Access Compliance Report

Public Rights-of-Way

Intersection ID: 11512	Main Street: N_SMITH_ST	Cross Street: W_7TH_ST	Location: S
ADA ID: 9EA116FD1026	Ramp Type: BlendTrans1	Initial Pass/Fail: Fail	Overall Compliance: No
		Severity Score: 10

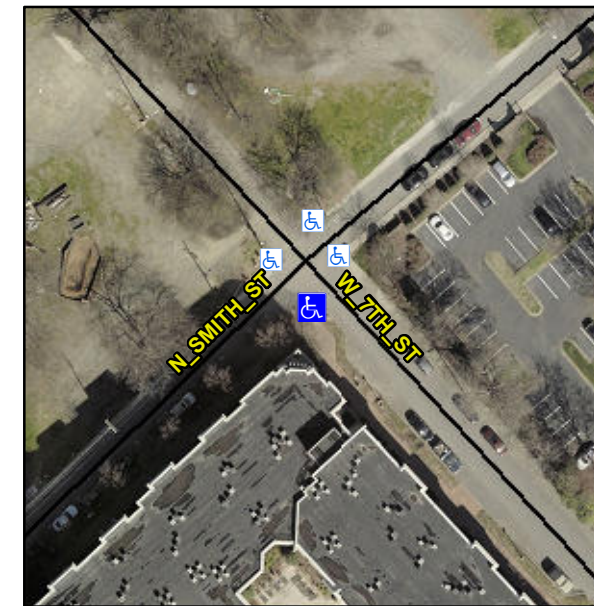
CURB LIP 1.5

Not Found, R304.5.1, R304.5.3

Compliance	Description	Data	Compliance	Description	Data
N/A	Ramp Length (in)	63.0	Yes	BlendTrans Slope (%)	4.5
No	Ramp Width (in)	44.0	No	BlendTrans XSlope (%)	2.3
N/A	Flare Type LT	N/A	N/A	Flare Type RT	N/A
N/A	Flare Slope LT (%)	N/A	N/A	Flare Slope RT (%)	N/A
N/A	Flare Traversable LT?	N/A	N/A	Flare Traversable RT?	N/A
N/A	Landing Length (in)	N/A	N/A	DWS Provided?	N/A
N/A	Landing Width (in)	N/A	N/A	DWS Contrast?	N/A
N/A	Landing Slope (%)	N/A	N/A	DWS Length (in)	N/A
N/A	Landing X Slope (%)	N/A	N/A	DWS Full Width?	N/A
N/A	Landing Curb? (Y/N)	N/A	N/A	DWS Offset (in)	N/A
N/A	Shared Landing?	N/A			
N/A	Gutter Ponding?	N/A	N/A	Gutter Slope (%)	N/A
N/A	Gutter Lip Ht (in)	N/A	N/A	Gutter X Slope (%)	N/A
N/A	Painted X Walk1?	No	N/A	Painted X Walk2?	No
	X Walk 1 Direction	To NE		X Walk 2 Direction	To NW
	X Walk 1 Width (in)	N/A		X Walk 2 Width (in)	N/A
	X Walk 1 Slope (%)	3.8		X Walk 2 Slope (%)	3.5
	X Walk 1 X Slope (%)	2.4		X Walk 2 X Slope (%)	1.2

N/A	Ramp inside XWalk1?	N/A	N/A	Ramp inside XWalk2?	N/A
	Road Slope (%)	0.5		Clear Space?	N/A
	Road X Slope (%)	2.1	N/A	Clear Space to XWalk (in)	N/A
N/A	Any Obstructions?	N/A	N/A	Storm Grate/Utility Hazard?	N/A
	Obstruction Type			Storm Grate/Utility Type	
		N/A			N/A
			Yes	Surface Condition? (G/P)	Good
			No	Curb Slope (%)	11.5

Remove & Replace Curb Ramp With Two New Directional Ramps or Equivalent.
